Palo Verde Nuclear
Generating Station

**Subject: Docket ID NRC-2011-0013
Palo Verde Nuclear Generating Station (PVNGS)
Units 1, 2, and 3
Docket Nos. STN 50-528/529/530
Comments on Proposed Generic Communication
Draft NRC Regulatory Issue Summary 2011-XX
Adequacy of Station Electric Distribution System Voltages**

PVNGS Comments on Proposed Generic Communication

Adequacy of Station Electric Distribution System Voltages

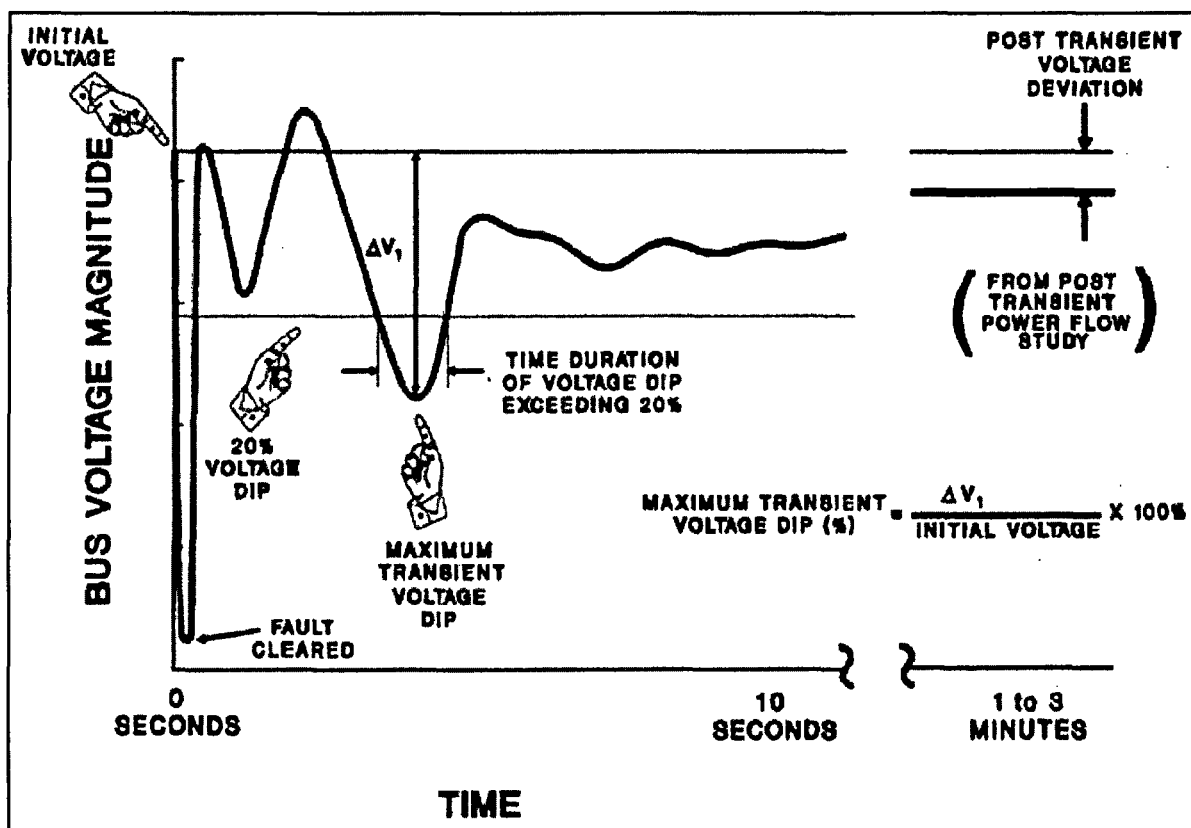
6. In light of the summary of the resolution of GSI-171, the draft RIS statement (page 7 of 10) that "(t)he time-delays(s) chosen for DVRs during accident conditions should meet the accident analysis assumptions..." does not seem appropriate. The degraded voltage condition could occur at various times during the initial energization of the accident mitigation equipment, and the relay time delay value only affects the additional time until the subsequent LOOP occurs.

The two time delays associated with the timing of the delayed LOOP are discussed in NUREG CR-6538 as follows:

“Thus, there are two types of delay before a LOOP occurs after a LOCA, i.e., the period after the LOCA (reactor and turbine trip) when the main generator is finally tripped (at least several seconds), and the delay of the undervoltage relays depending on the severity of the voltage drop (again, at least several seconds). In addition, these two types do not completely overlap because the delay related to the undervoltage relays will probably start timing-out some time during the delay related to the main generator trip, or even after this latter is completed. Therefore, to some extent, it is likely that the two delays will result in a total longer delay.”

Furthermore, if load shedding is blocked during sequencing, as required by BTP PSB-1, the delayed LOOP will be delayed until sequencing is complete, regardless of the DVR time delay setting. Therefore, a defined correlation between the time of protective actuation and accident analysis assumptions does not appear to exist. Further, any basis or analysis to conclude that setting the DVR time delay in accordance with the specified criterion would be of any advantage to prevention of the failure mechanisms discussed in the resolution of GSI-171 is not provided; and shorter time delays increase the probability of spurious delayed LOOP events.
